Snouffer School Road North (Webb Tract)
Part C: Preliminary Forest Conservation Plan, MR2014038

Completed: 5/16/16

Description

SNOUFFER SCHOOL ROAD	
FCP	
SHEET FOUR	
SCALE: AS SHOWN	Project No.: _____ SHEET 4 of 6

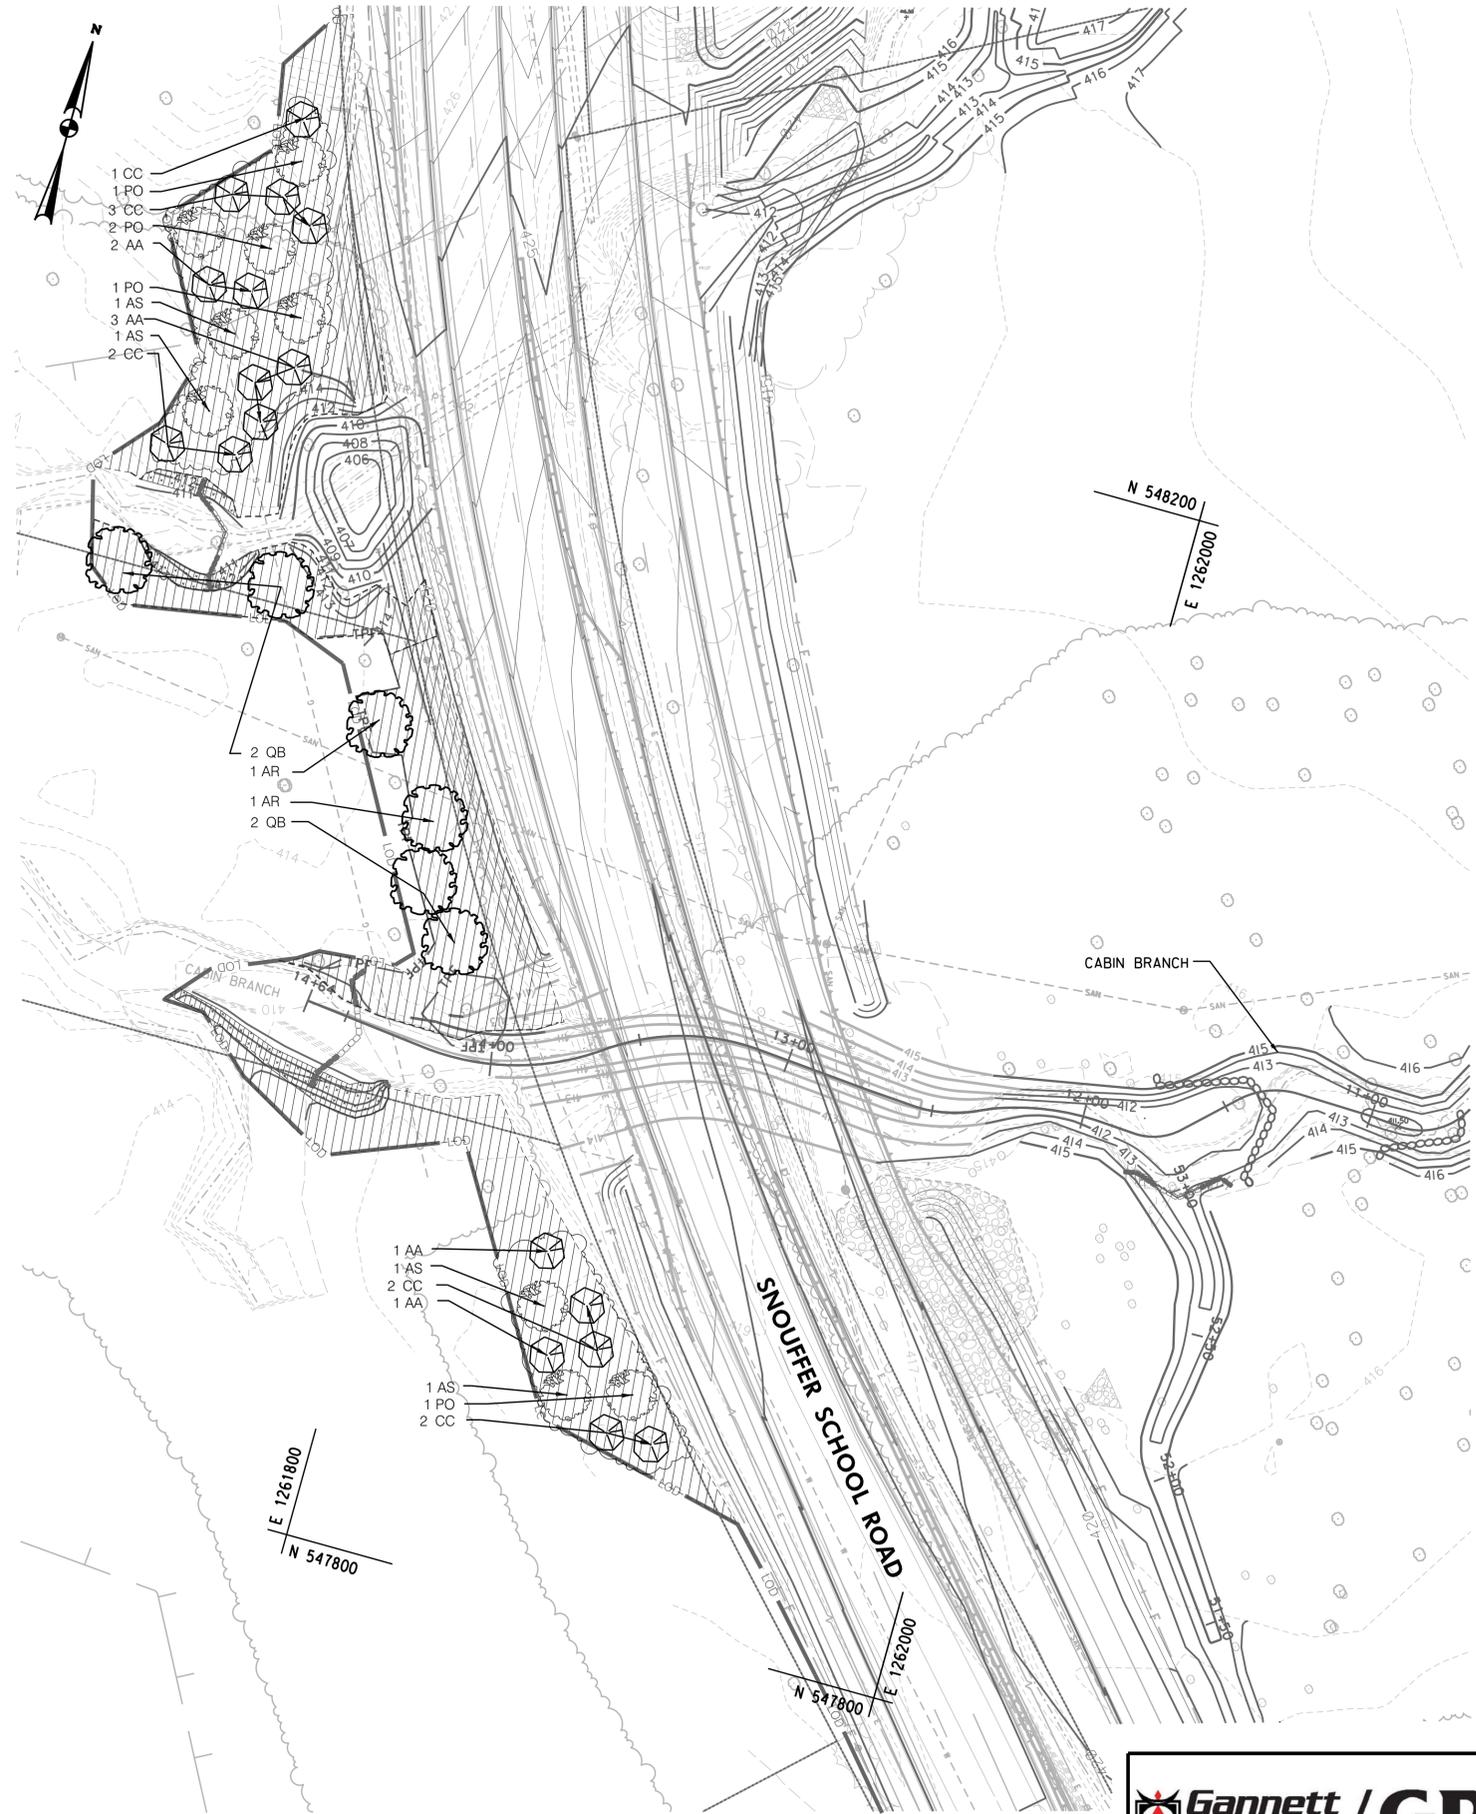
- b. The Forest Conservation worksheet must show the correct net tract area and reforestation requirement.
 - c. The Applicant must plant a minimum total of 18-caliper inches of native canopy trees as mitigation for the tree variance impacts on the Site within one calendar year or two growing seasons after completion of road construction. The trees must be a minimum of three-inch caliper each.

- d. The Final Forest Conservation Plan must show how the 1.30-acre reforestation requirement will be met.
 - e. All areas of forest plantings must be outside of right-of-ways and utility easements.
